**Parks & Recreation Advisory Commission Agenda
5:30 pm Wednesday, July 13, 2022
Council Conference Room & Hybrid**

Unity Park

UNITY PARK
City of Ellensburg, Washington

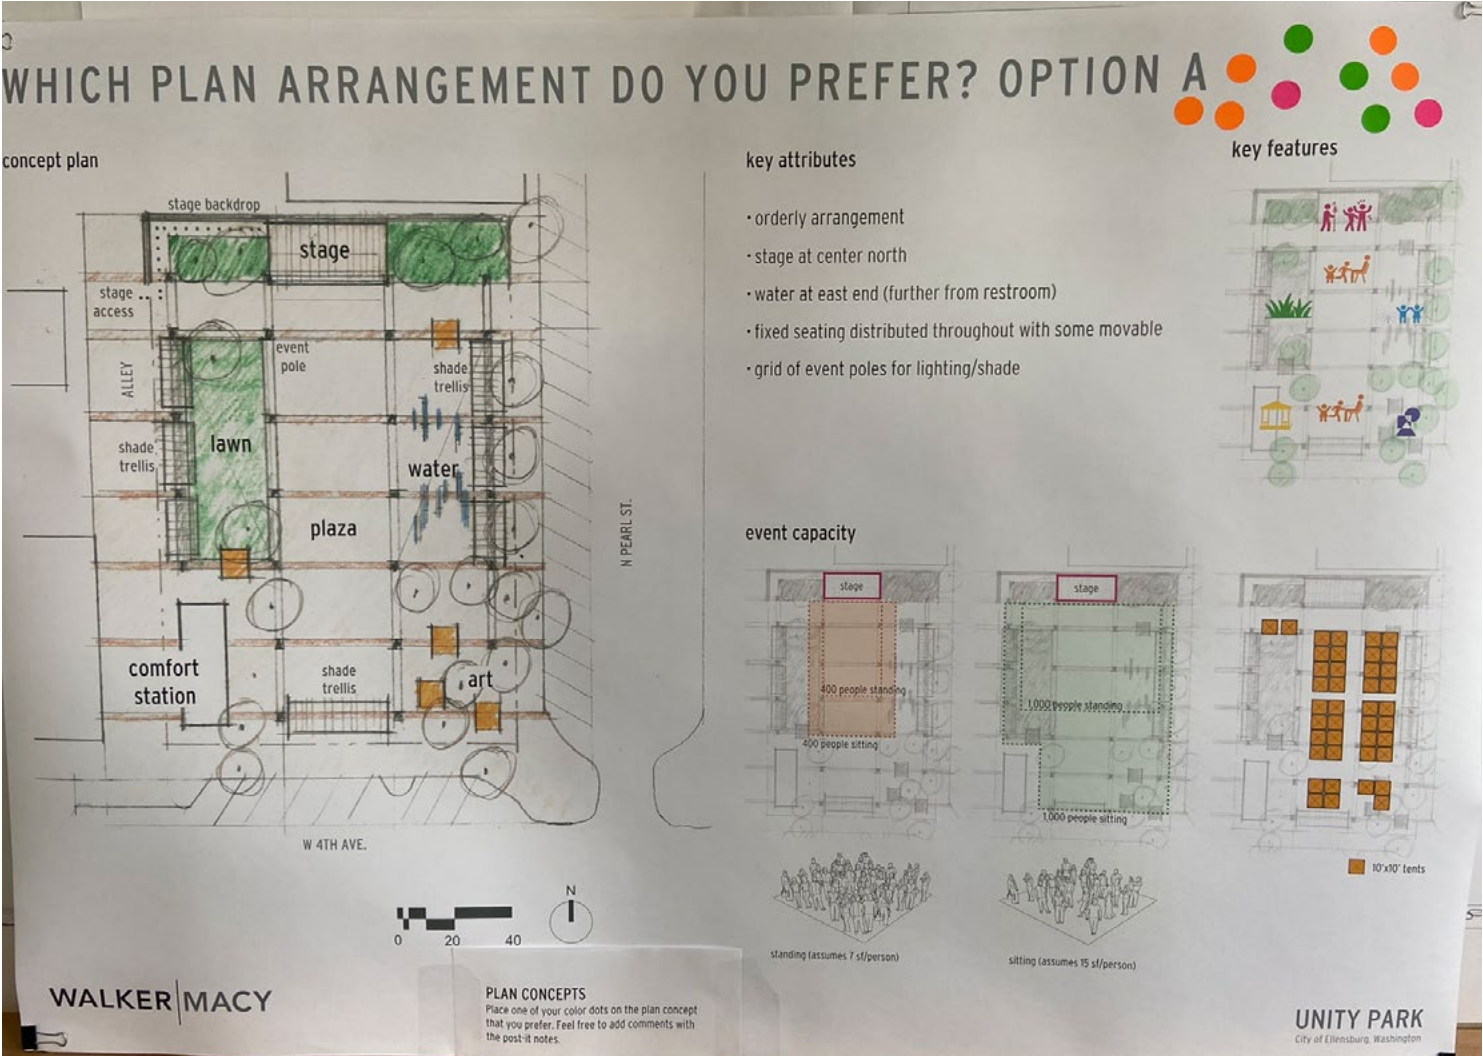
Inside Retainer walls are 18 inch benches. East wall is 48" high with 3 wind arts mounted; West wall is 8' high with 2 foot art panels.

Turnkey stage with chairs and storage behind stage.

Existing bank and drive through building is retained. The north side is modified with garage doors with only one fully functional. This creates an all weather sheltered picnic space in 3 bays. The west bay is modified to becomes 2 unisex restroom with central outside sink and water. The east bank window is modified to be a visitor information kiosk.

Premium 298 paring spaces in the "gold H zone." 17 additional spots provided along the ally. Possible charging station in the future.

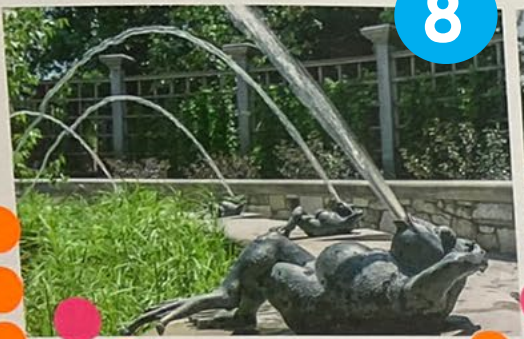
Option B Comments:

- pro: encourage movement thru, offers paths and internal destination, potential for clearer visual clues
- angled stage will provide a good site line into 4th and Pearl for drawing walkers to the state
- under surface heated snow/ice melting
- rounded curbs - how will this impact snow removal?
